SEWAGE DISPOSAL SYSTEM

A REPAIR

SUBDIVISION _____ ROAD 12409 Lime Kiln Road LOT _____

APPLICATION

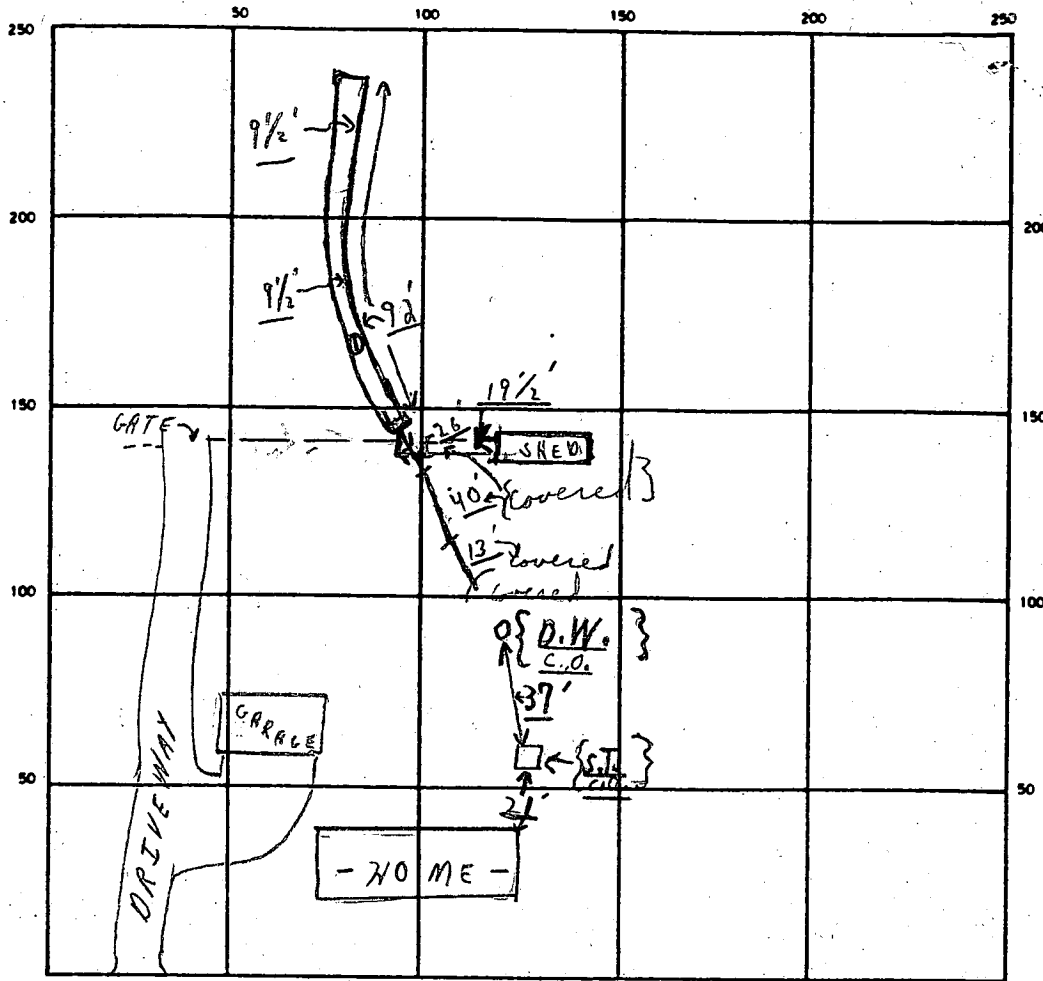
SEPTIC TANK LEVEL No - Existing CLEANOUTS No ↔ Existing - ok

DISTRIBUTION BOX LEVEL No!

REMARKS 12/14 ① Partial - solid pipe covered to trench - 70' long
12/14 ② Trench being completed, OK TO COVER. C.B.S.

{ 2' wide, depth 3 1/2', 6 FT of stone, in area as shown
on other side, 90'+ long. C.B. }

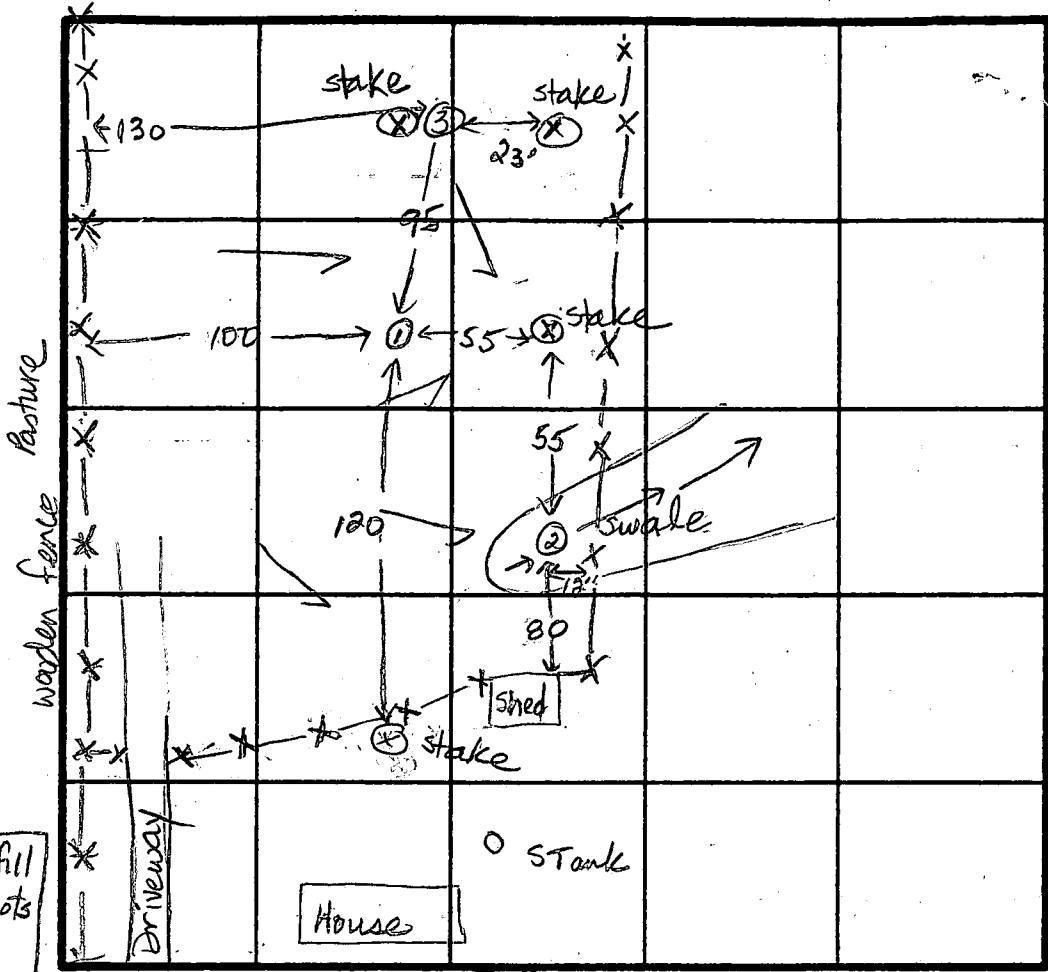
REASONS FOR REJECTION OR HOLDING For perc. hole location and soil
plan review. Repairs require pumped septic system.
JEN 3-26-92

DATE	TEST NO.	DEPTH	PRE-WET		TEST - 1" DROP		TIME
			START	STOP	START	STOP	
3-25-92	1	3.5 S 13.5 D	1:23:19 <15%	1:25:44 rock	1:25:44 fragg	1:29:45	4min ok
	2	5.5 S 12.5 D	1:31:59 Bottom	1:34:39 <5%	1:34:39 rock	1:38:00	3min 29 Fail
	3	12.5 V	Rock w/ structure at 7.5 ft				Fail

REMARKS: Move uphill, keeping 30 ft off #2 & 3, Requires pump.
TYPE OF SOIL: 0-4 Red-br si c loam, 4-13 Br mica s si l, <15% rock fragg
TESTED BY: JE Nadeau ALSO PRESENT: Olenk, Hugh
